GARAGE - REVISED FRAMING PLAN

Roof removed · north up · every primary member labeled

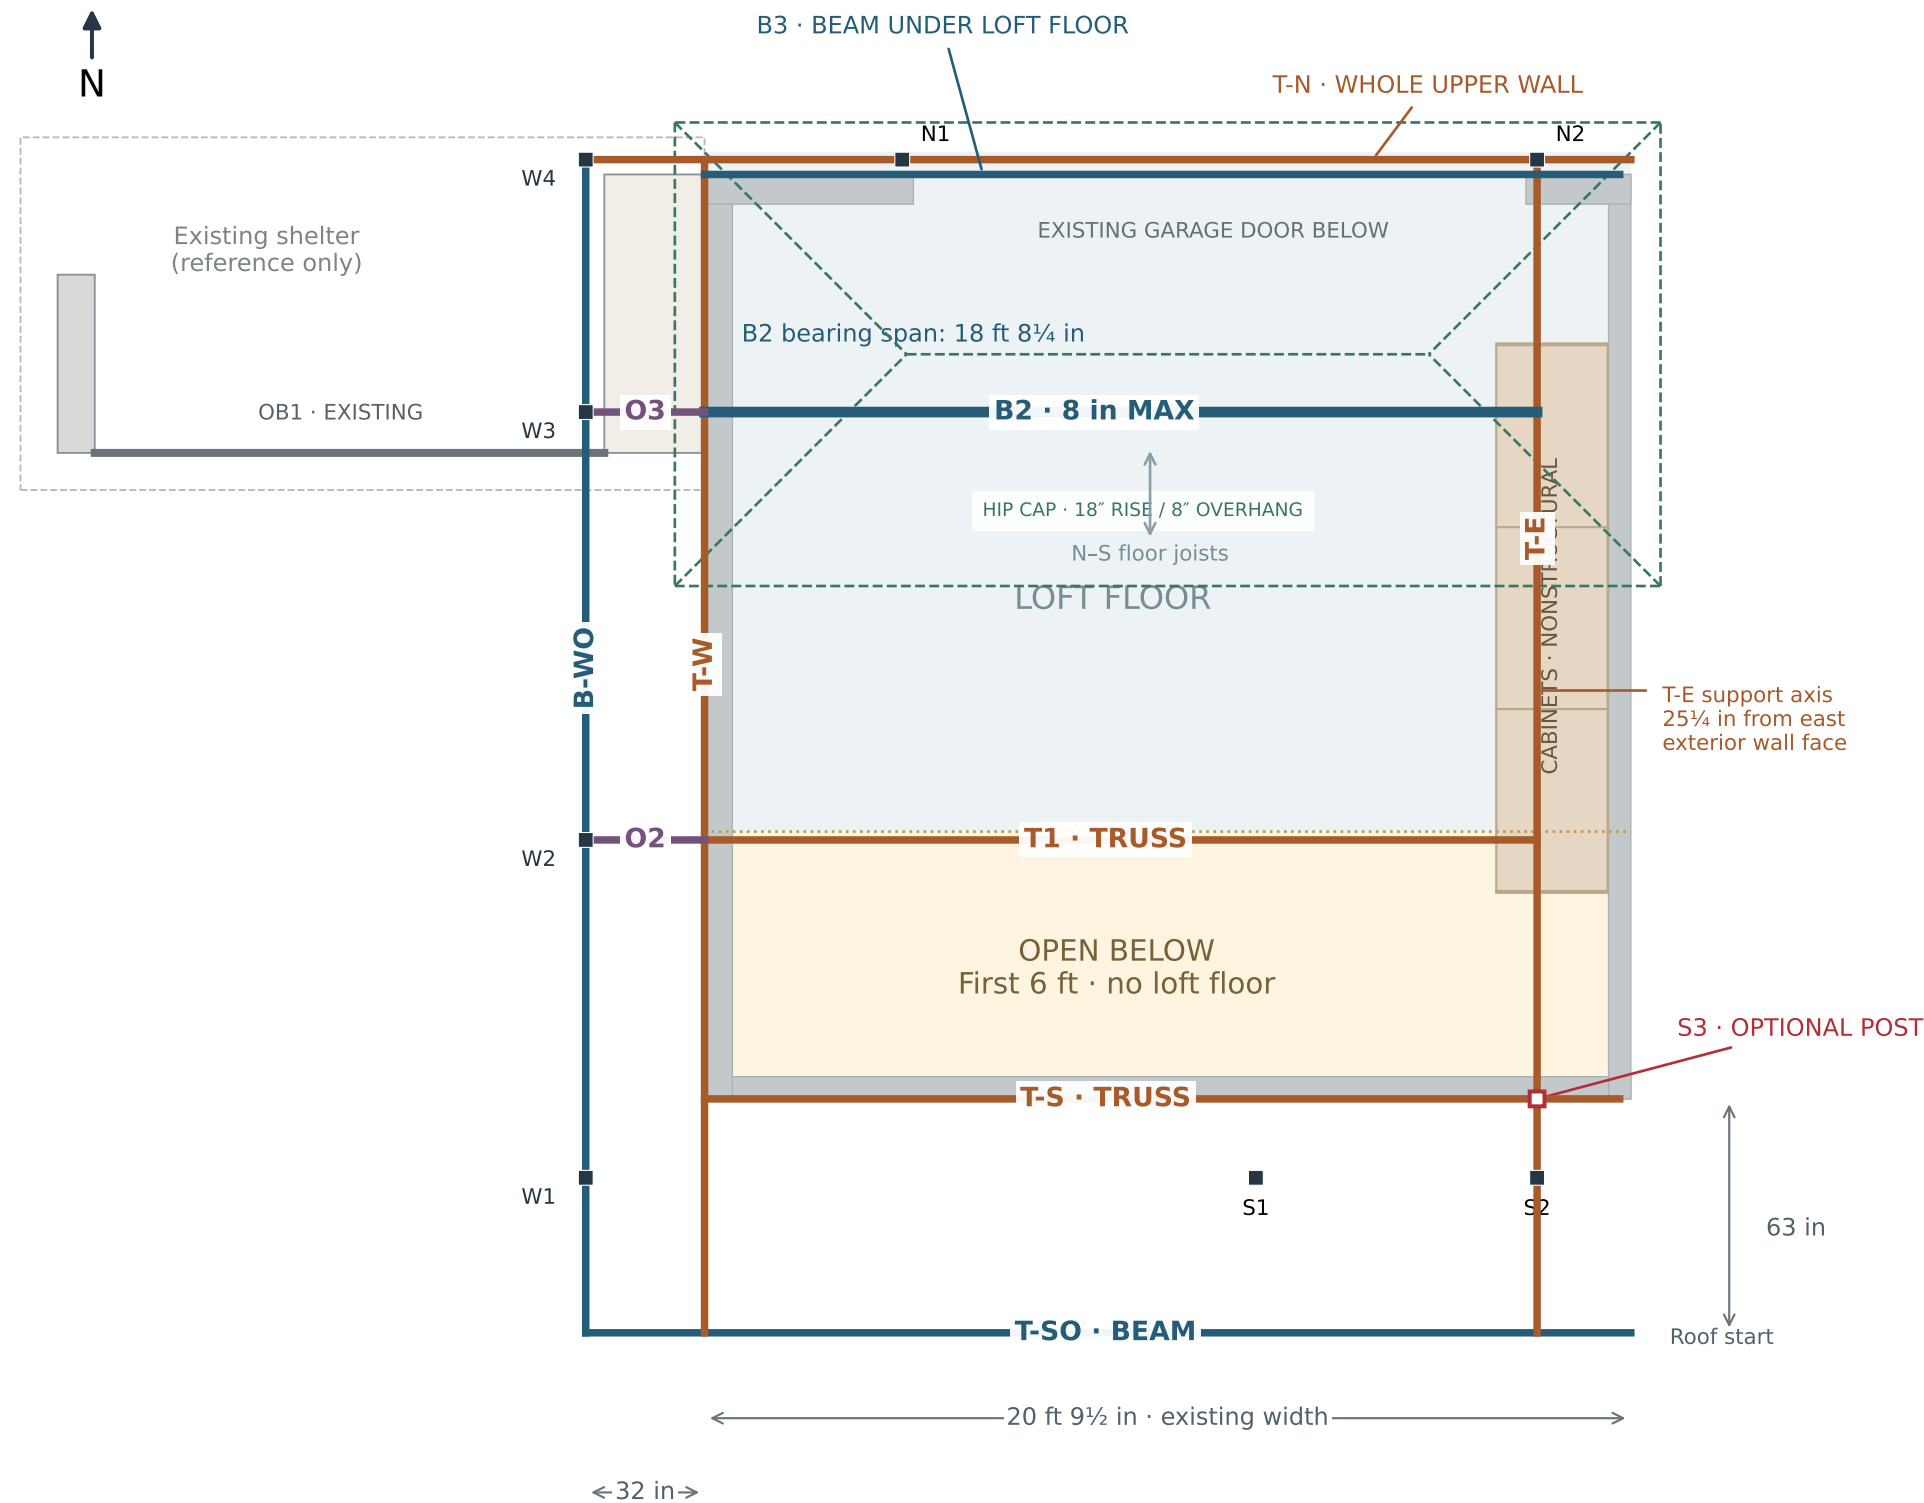
- S2 moved east 12¾ in to align with N2.
- Gray = existing walls; brown fill = cabinets.
- Hollow red S3 = optional 4-inch post.
- Solid orange = truss; B-S removed.
- Truss depth is vertical, not plan width.
- All bottoms = wall top; columns carry loads.

Every beam / truss bottom is at 8 ft 2½ in, aligned with the wall tops. Loads go to columns, not the old walls.

Concept only: T-SO is 63 in south of T-S. B-S removed; south support-row / T-SO bearing details remain unresolved.

The previous east-wall trial post E1 is omitted from this option; it no longer aligns with T-E. Cabinets remain nonstructural. Beam sizes and transfers require reanalysis.
